J. H. FLETCHER & CO. Box 2187 – Huntington, WV 25722-2187 – 304/525-7811 – FAX 304/525-4025

INFORMATION BULLETIN NO. 114

TO: OWNERS, OPERATORS AND REBUILDERS OF J.H. FLETCHER & CO. TWO-LEG HINGED CANOPY

SUBJECT: DAMAGE TO TWO-LEG HINGED CANOPY

ATTACHMENT 2

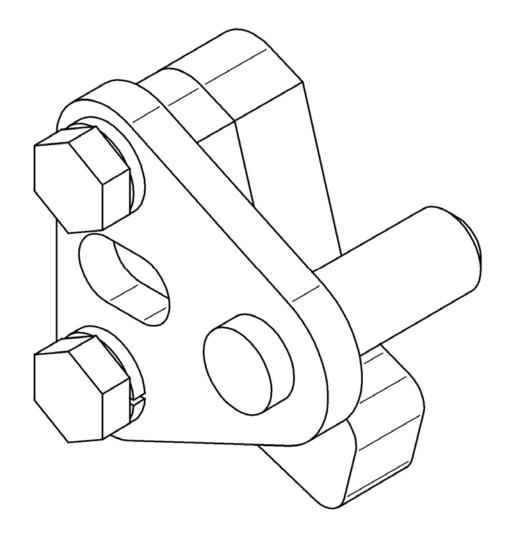
"tram canopy stops" (Attachment 2). The available canopy stops are designed for a two-leg hinged type of canopy arrangement only. When placed on the canopy leg supports, the canopy stops prevent the canopy from falling all the way to the frame if the canopy support cylinder or its attachment to the canopy is broken (Attachment 3).

The tram canopy stops are being offered only as an additional mechanism to prevent the canopy from falling all the way down to the deck frame if the canopy support cylinder or its connection to the canopy or frame become broken due to a collision with some object.

- Contact Fletcher's Service Department or your local Fletcher authorized distributor to order the stop (part no. 422007). Provide the serial number of the machine(s) for which you are ordering the stops and you will be given a quote for the stop(s) for your specific machine(s).

- 3. Your machine will be equipped with either a hydraulic cylinder or a manual adjust post. If your machine is equipped with a hydraulic cylinder, when you receive the stops it will be necessary to change the hydraulic circuit. Fletcher requires that you change the tram canopy cylinder hydraulics so that when it is activated it is gravity feed down only. Pressure down of the tram canopy cylinder could cause damage to the canopy, hydraulic cylinder, or tram canopy stop.
